Melton East PSP

Submission to Amendment C244melt

3L Alliance

31 MARCH 2025

Figure 2 – Melton East PSP – Key Identified Issues

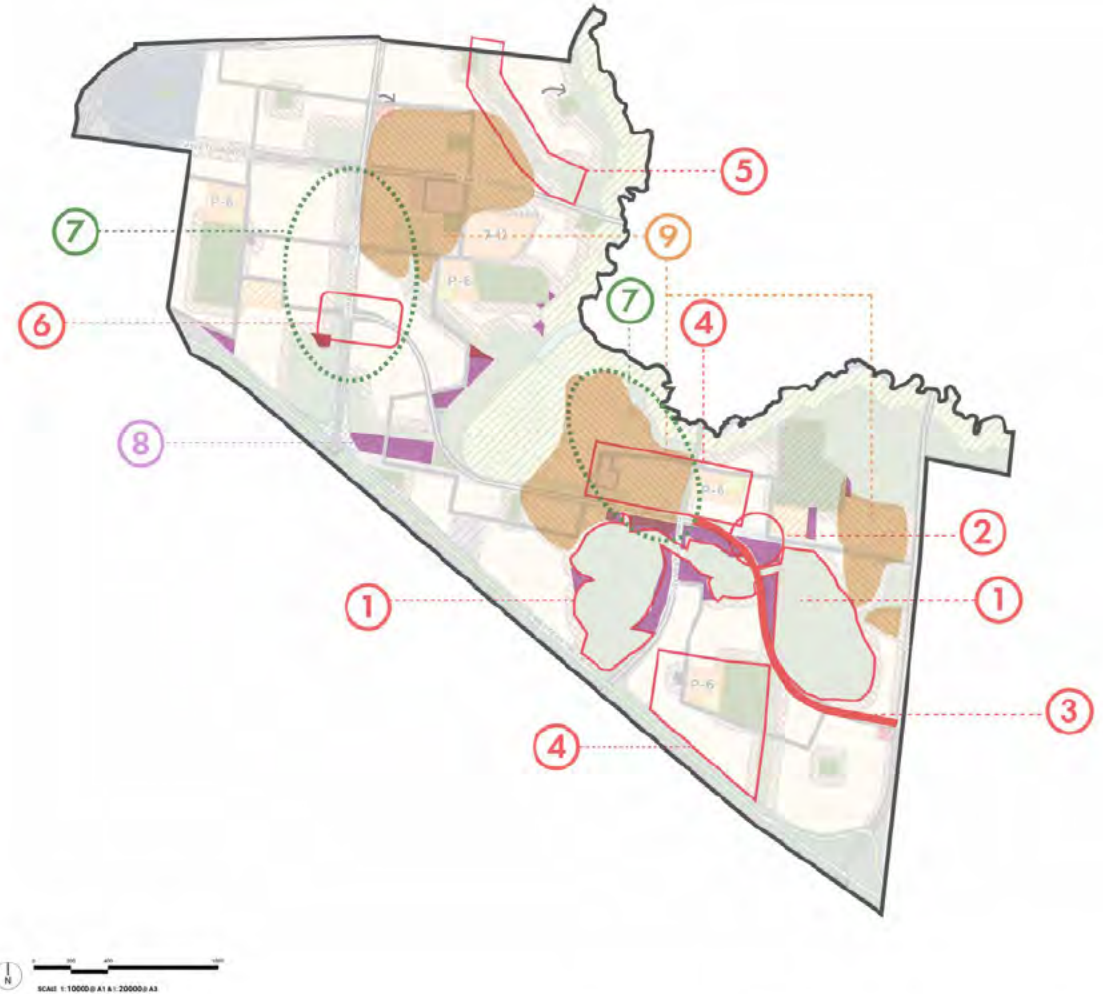
3L's overarching key issues are identified spatially through a marked up version of the Future Urban Structure (FUS) (Figure 2) and can be summarised into the following eight key matters.

Figure 4 – Melton East PSP – Areas of unrealisable or heavily constrained NDA

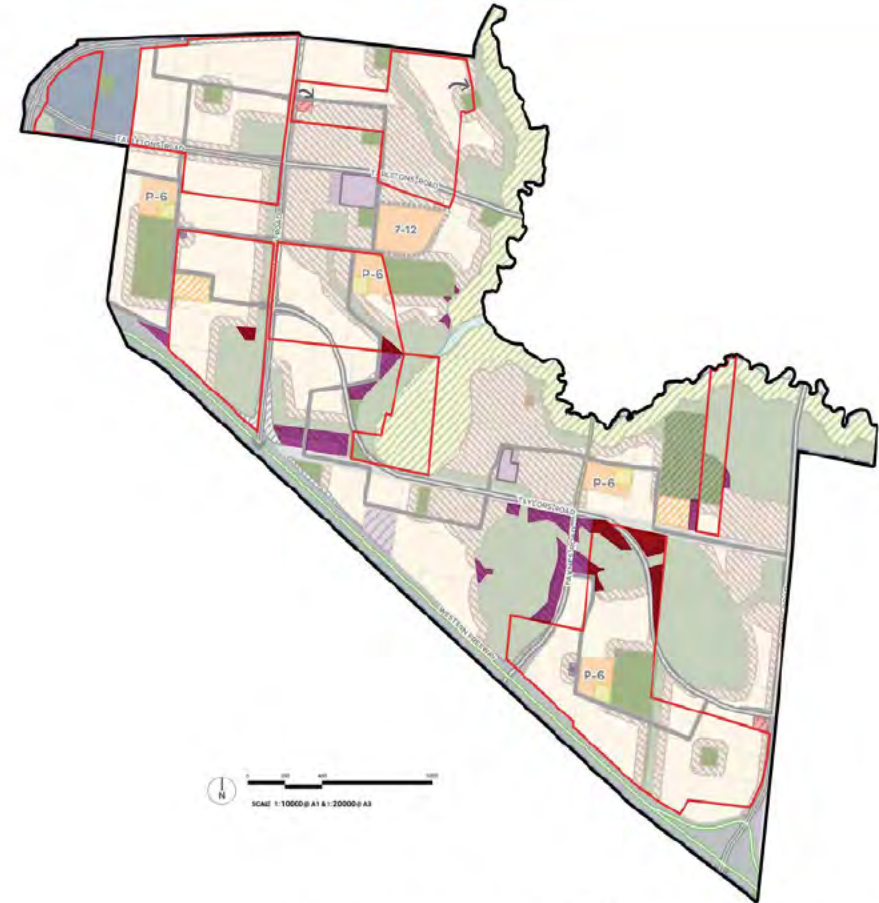
25.4ha of the PSP is located in areas where the NDA is either unrealisable or heavily constrained.

Figure 6 – Melton East PSP –Areas outside walkable catchments to key open spaces

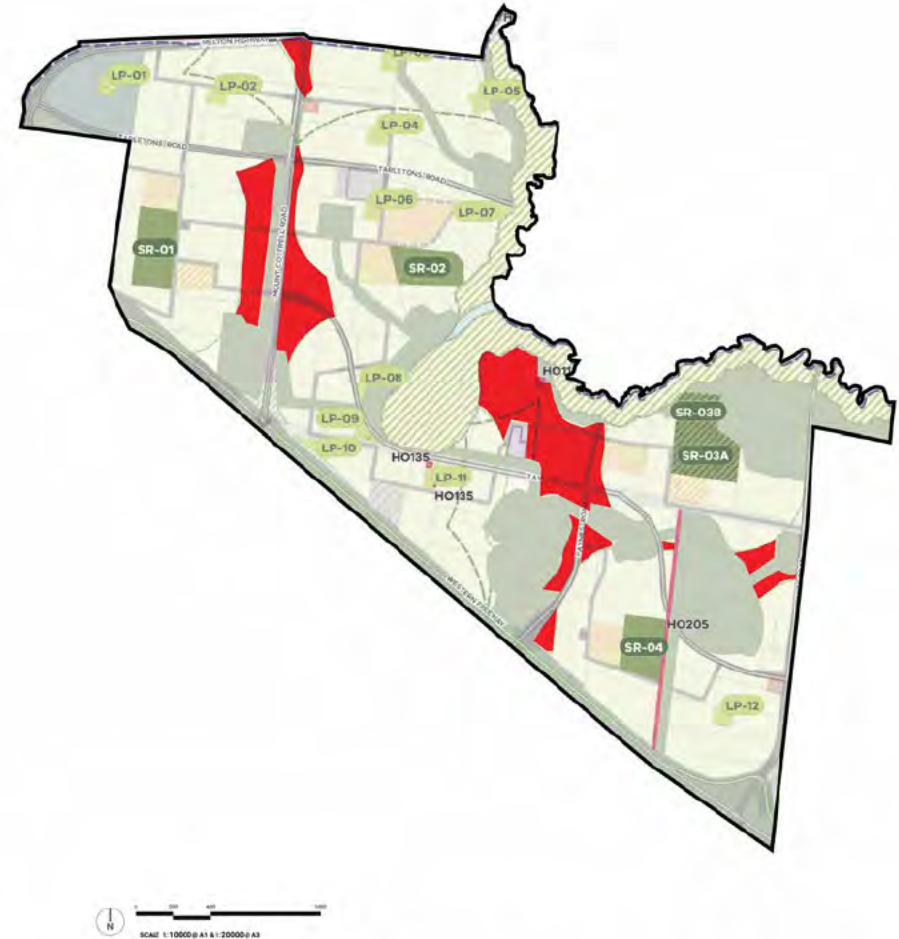
21. The location of local parks be revisited to ensure equitable distribution and accessibility to the local park network across the PSP consistent with the PSP Guideline targets.

Figure 7 – Melton East PSP – Density Testing Scenario 1

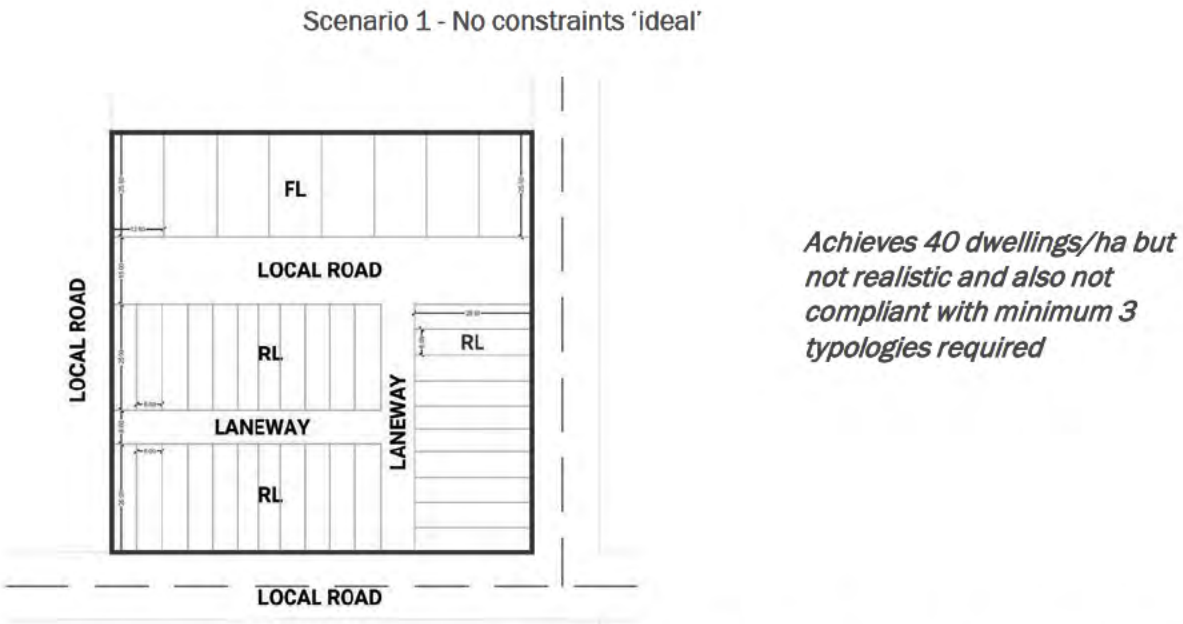
The alternative to apartments to attain 40 dwellings/ha requires 100% of building stock to be narrow urban townhouses, resulting in extensive rear laneways throughout the PSP, regardless of requirements on length and will reduce the opportunity for building and typology variation.

10. Removal of average 40 dwellings/ha as an expected density within the PSP.
11. The requirement to distinguish between high amenity and amenity areas be removed. Amenity should be defined as per the PSP Guidelines – “locations where communities will be naturally supported by key features such as open space, activity centers, community facilities and access to public transport.”
12. All amenity areas should be refined to aspire to a preferred density of minimum 30 dwellings/ha.
13. That an overarching PSP target for a minimum of 23 dwellings per ha be nominated in order to ensure viable densities are achieved across the PSP.
14. Densities be described as a minimum rather than an average.
15. The prescriptive nature of the requirements in the PSP should be reduced to allow a more adaptable response to housing diversity over time.

Figure 8 – Melton East PSP – Noise Influence Areas

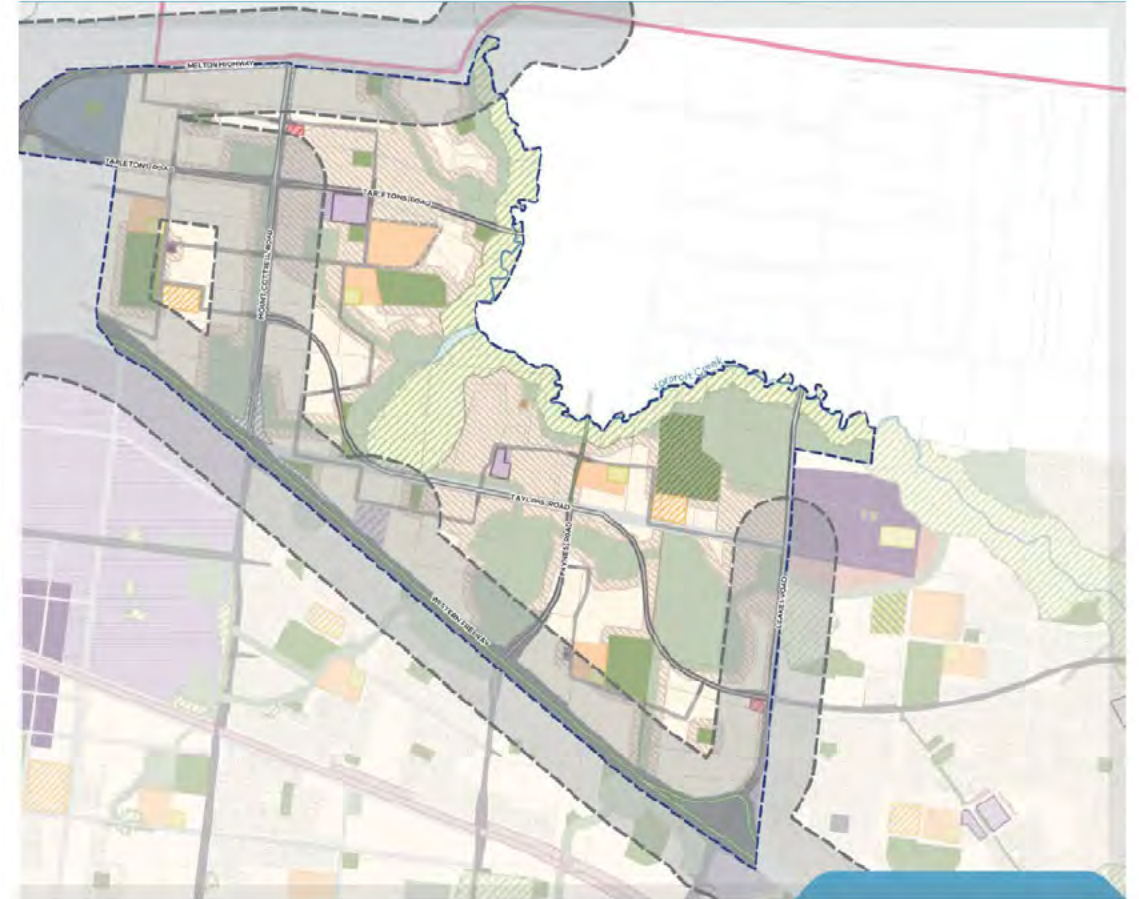
22. The requirement for acoustic treatments per cross section "Freeway Interface" be limited to the interface with the Western Freeway only.

Figure 11 – Melton East PSP –Drainage assets

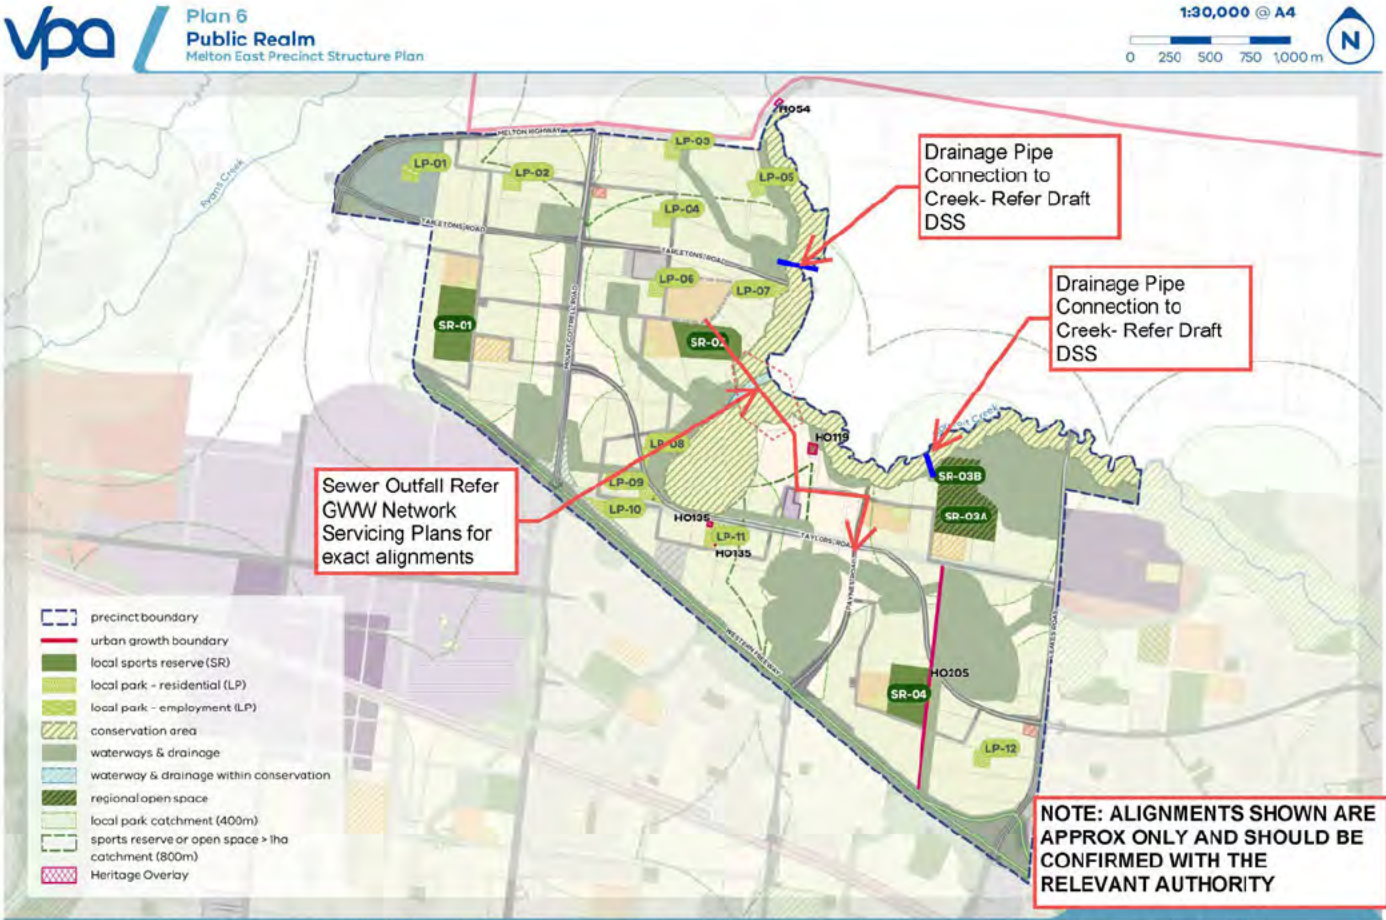
Figure 11 shows two drainage pipe outfalls through conservation areas, and one trunk sewer traversing it. The drainage assets are shown in the draft Alluvium DSS, and the sewer trunk main is shown in Greater Western Water's Network Servicing Plans.

45. Asset crossings in Figure 11 be included in Plan 6 and 7 of the ME PSP to ensure they are recognised within the PSP and are appropriately planned for.

Figure 14 – Revised staging plan

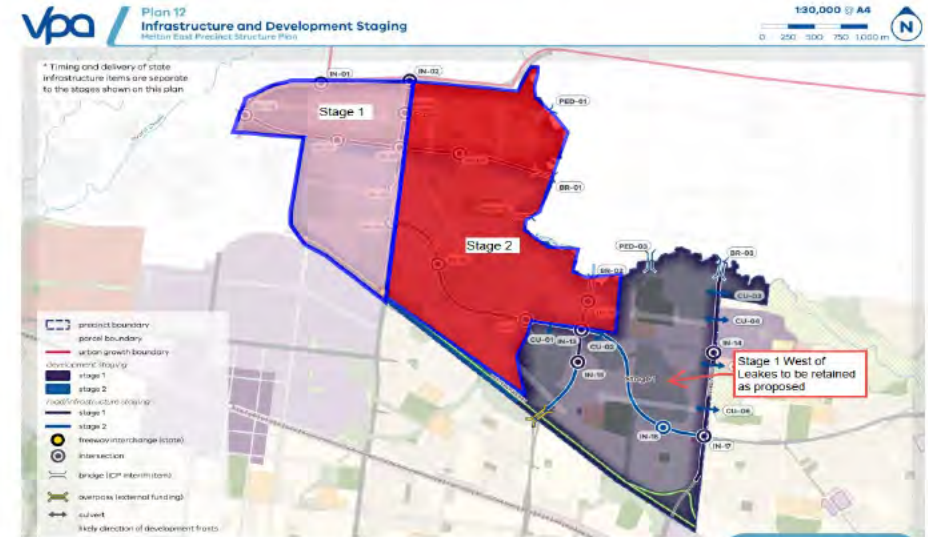
Further, the ME PSP provides no directions in relation to when stage 2 could commence. We support the staging being a guide rather than explicit. From our previous experience it will be unlikely that land within stage 1 will be fully developed prior to demand for development within stage 2. *We note G46 in relation to out of sequence development, however the PSP could be reinforced to allow for appropriately sequenced development in the context of the staging plan.*

55. As per the recommended approach to staging included at Appendix 3 and Figure 14, we seek:

- a revised staging approach to ensure orderly servicing and the delivery of incremental infrastructure to support the growing population;
- sub-staging which supports interim / part delivery of assets to reduce cashflow demands;
- the inclusion of mechanisms be built into the PSP to deal with access to neighbouring land that will be required for servicing and drainage purposes, for example, through the application of PAOs;
- the Beattys / Taylors Road intersection detail in Appendix 3 to access NH1; and
- flexibility to bring forward Stage 2 land where developers are prepared to fund infrastructure.

Figure 15: Comparison of ICP Transport Levies
Source: Ethos Urban, based on gazetted ICP documents. Values indexed to 2024/25 year.

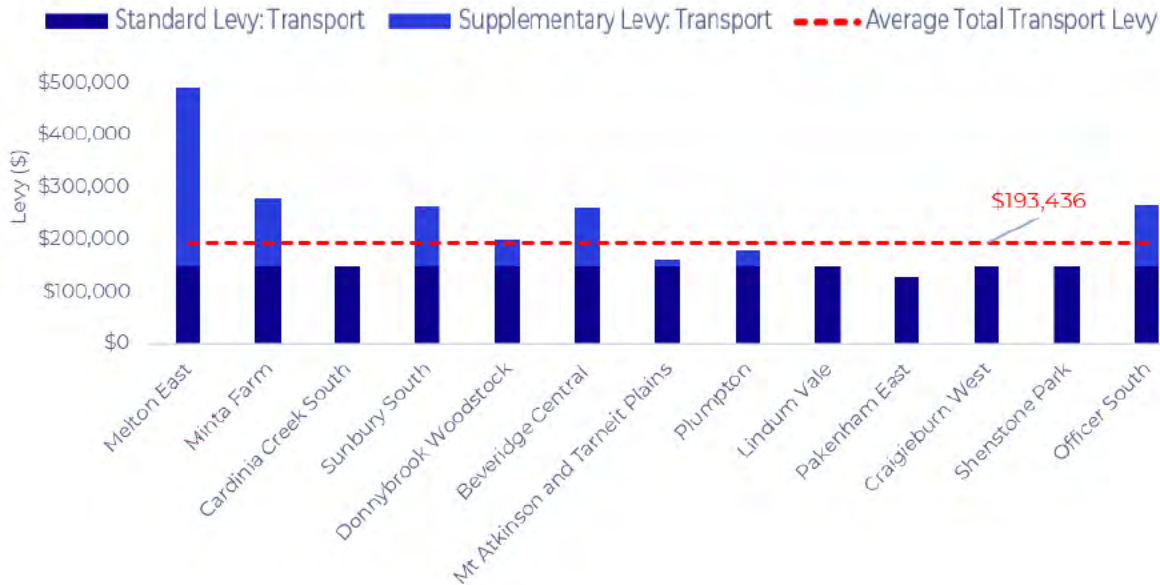
56. Impact on affordability to housing supply needs to be reviewed. For this PSP to be affordable the supplementary ICP needs to reduce inline with other recent PSPs (see Figure 15).

Figure 16: Land Take not recognized in Land budget

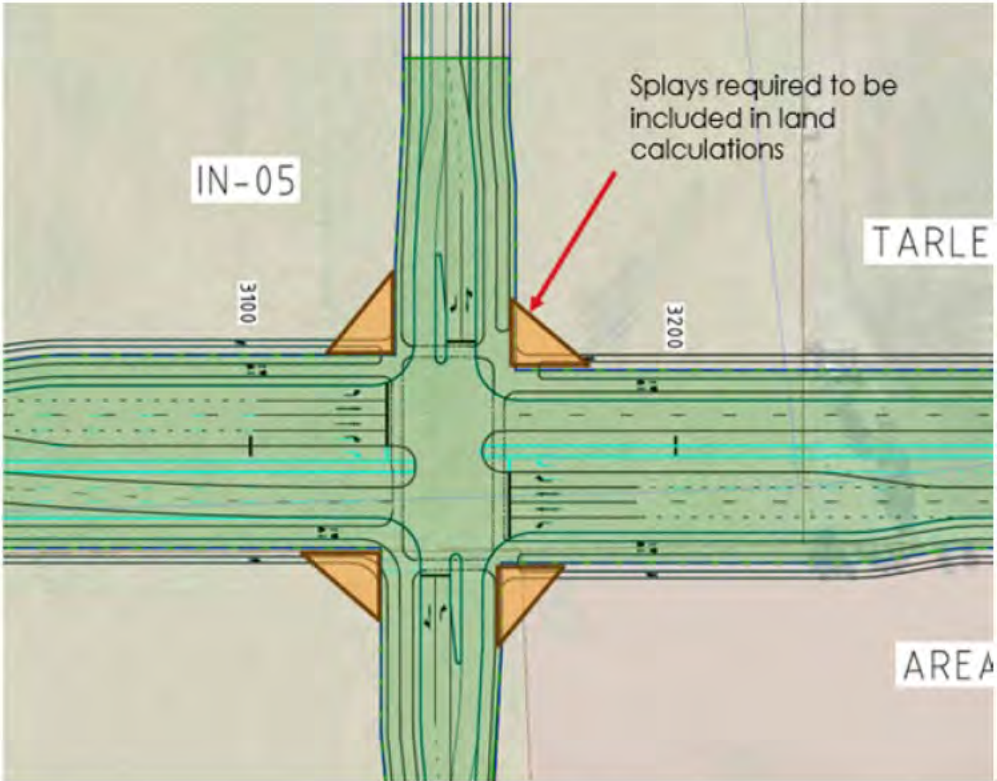
64. Land take calculations to include the full cross section including allowance for splays at intersections as per the Figure 16.
65. ICP to be updated to include assumptions around utilities, retaining walls or other infrastructure.

Figure 75. Waterway 8&10 functional design (Kororoit Creek Upper DSS)

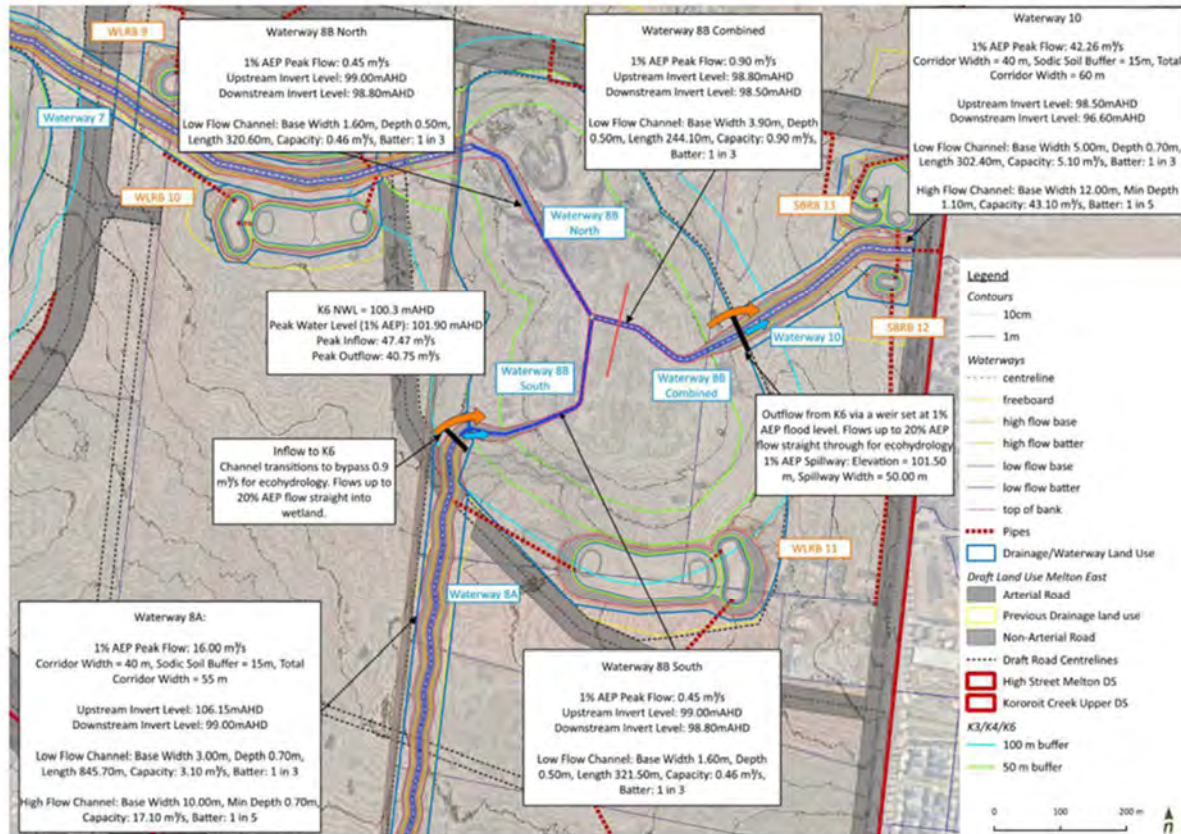
- There appears to be an incompatibility between the hydraulic arrangement described within the eco-hydrology model and the report. Within figure 75 of the report, pictured below, a low flow bypass is shown trisecting the existing depression. Spiire understands that the low-flow pass is intended to let regular flows (0.9 m³/sec) to bypass the K6 depression, with flows exceeding this to surcharge into the depression. This arrangement is intended to manage developed flows while also retain as much as possible the historical wetting regime of the depression. The use of the term 'historical' is not explained within the report.

- According to figure 75, the low -low bypass is free draining up until the 20% event, however the K6 depression is intended to hold water for an extended period.
- The pond node, representing K6, within the MUSIC model does not have a free flowing outlet until the water reaches 1.0 m of depth. This contrasts with having an outlet free flowing up to the 20% event at the invert of the depression.
- In-line with Figure 75, at an outflow of 0.9 m³/sec the pond will empty within 72 hours from full. The volume for this was taken from the music model.

Figure- WLRB0 Suggested Outfall.

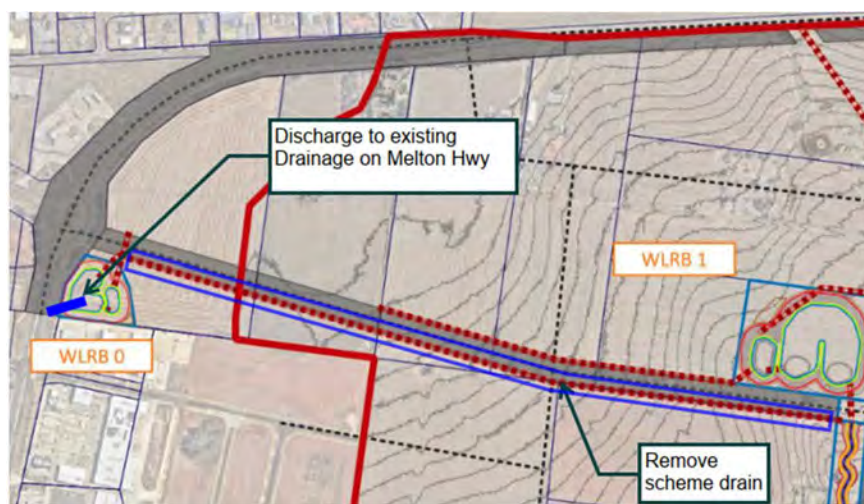
- ▶ Remove scheme drain and discharge asset to Melton Highway drainage, refer figure below.
- ▶ Based on site inspections- there is existing piped drainage and a swale in Melton Hwy which this catchment can discharge to:

Figure- Waterway 1 removal and WLRB3A/

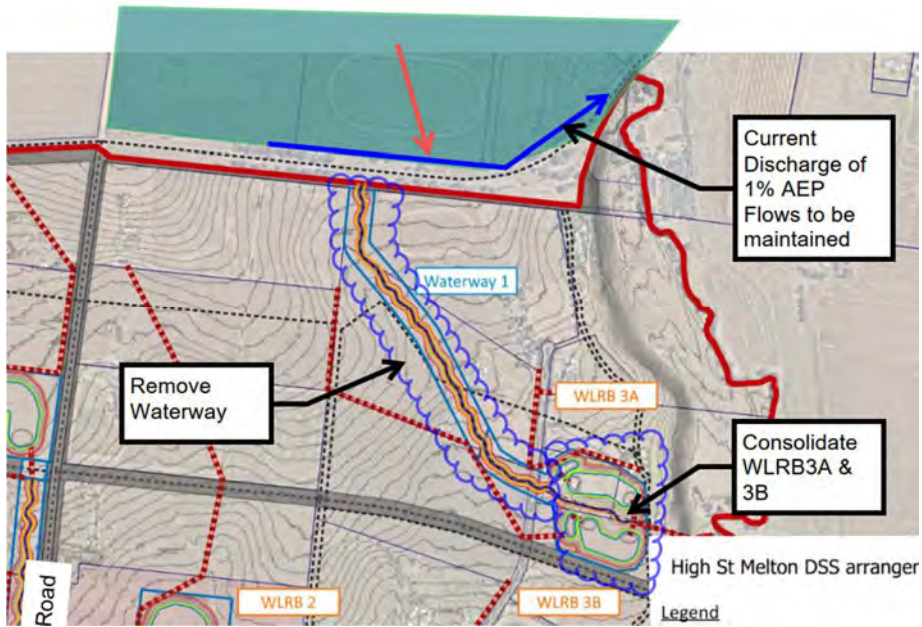
- ▶ Remove Waterway 1.
- ▶ Consolidate WLRB3A and WLRB3B into 1 asset.
